**42 HAMPSTEAD LANE
LONDON, N6 4LL**

NMA APPLICATION II
FEBRUARY 2024

SUMMARY OF CHANGES

CONSENTED VS NMA ii PROPOSALS

CONSENTED LOWER GROUND FLOOR
(REF HGY/2023/2998)

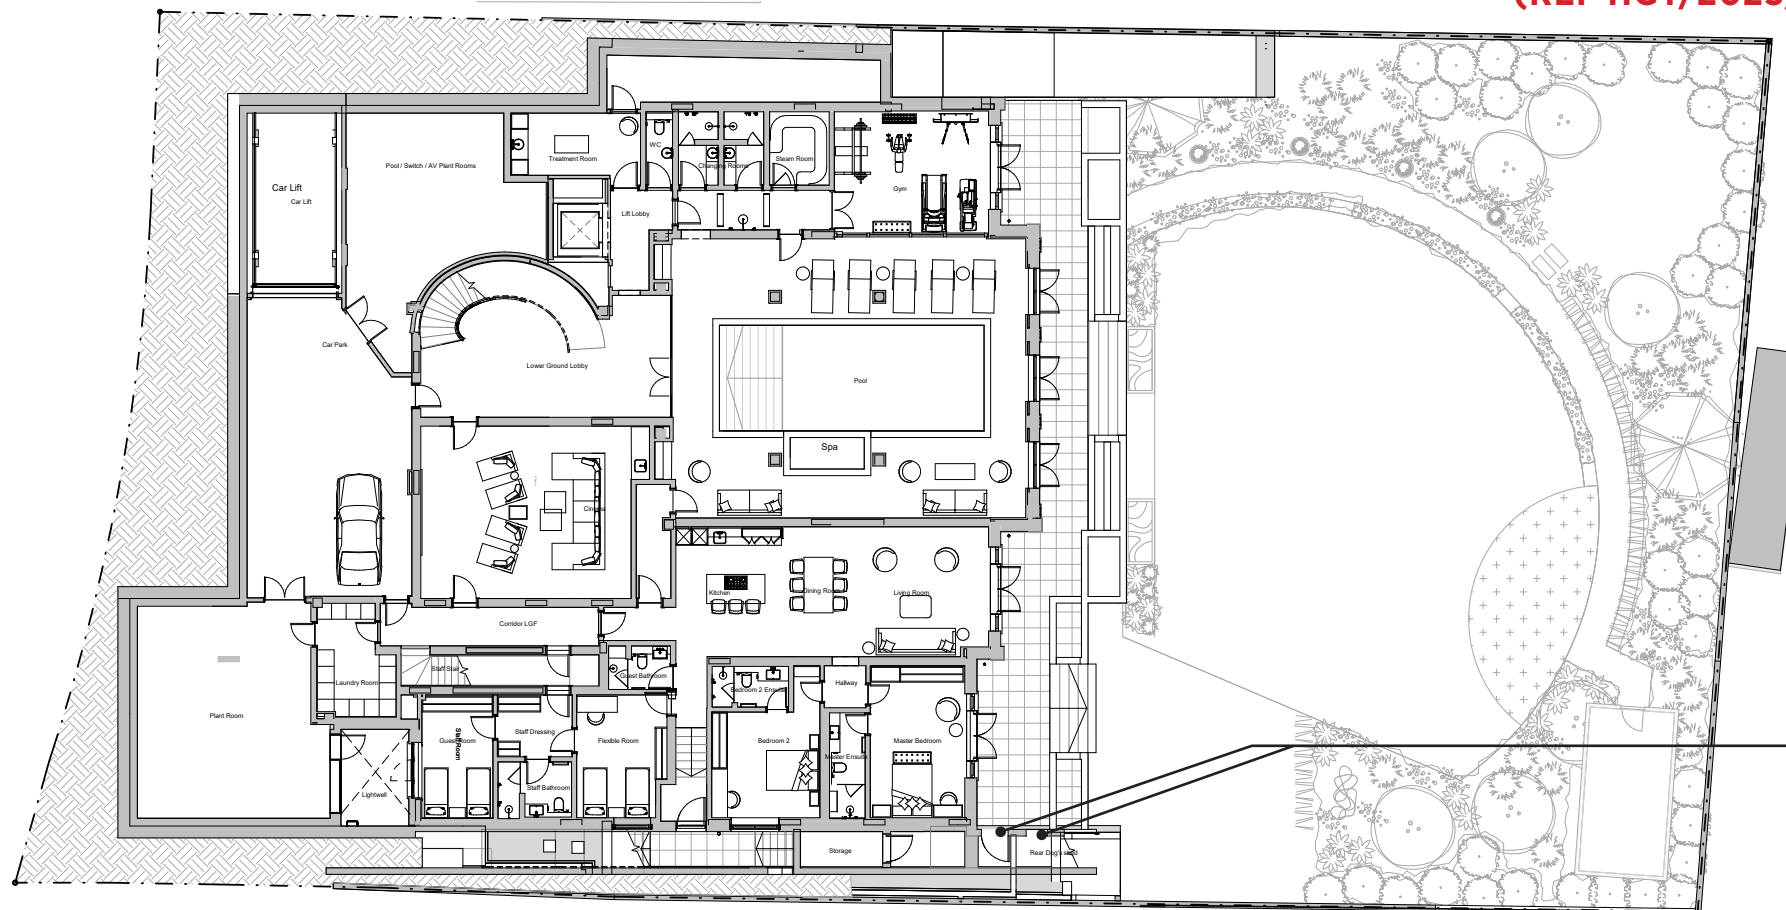
1. New door and new small gate
for dog's shed to rear stairs.
